File: A066/20

Minor Variance
Application

Property: 63 Couture Gardens, Thornhill

Purpose: Relief from the By-law is being requested to permit a proposed walk out basement and shed. Relief is also being requested to permit the existing covered deck in rear yard.

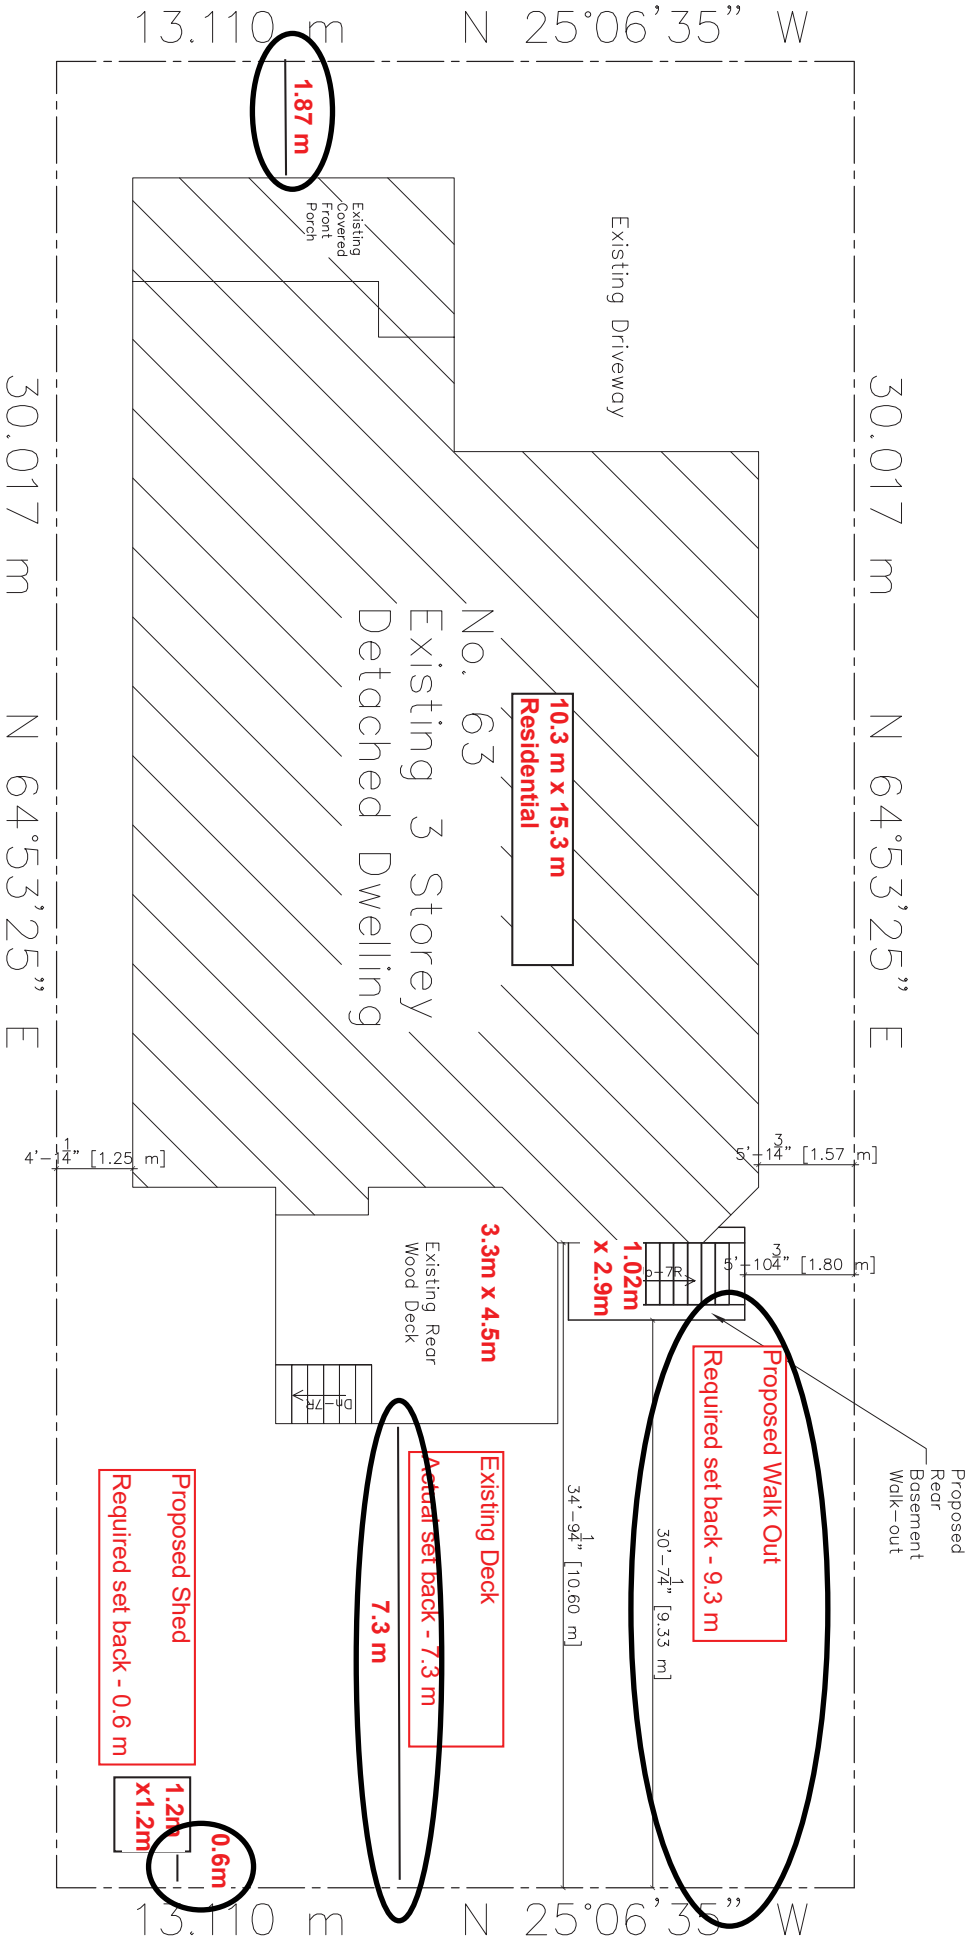
The Development Planning Department has no objection to Variance 1, as the reduction is minor in nature and appropriate given the exterior stairs maintain an interior yard setback that is complaint and properly screened by a vegetative strip.

The covered deck (Variance 2) provides an adequate distance needed to preserve the Woodland feature to the east. Additionally, a 7.3 m rear yard setback is consistent to those of the surrounding properties, remains proportional to the width of the home and maintains provides a large amenity area in the rear.

The proposed shed (Variance 3) provides the minimum distance needed to properly address and manage water run-off. The Policy Planning and Environmental Sustainability ('PPES') Department has confirmed that the placement of a less than 10 m2 shed will not disrupt the stability of the soil, nor cause any adverse effects onto the surrounding vegetation.

The Development Planning Department has no objection to Variance 4, as there have been no changes to the existing size and area of the porch. The existing Owner has enclosed the porch in glass casing, reducing the distance of the nearest wall to the front lot line. The Development Planning Department is of the opinion that the glass enclosure of the porch does not affect any sight lines nor increase the mass of the home.
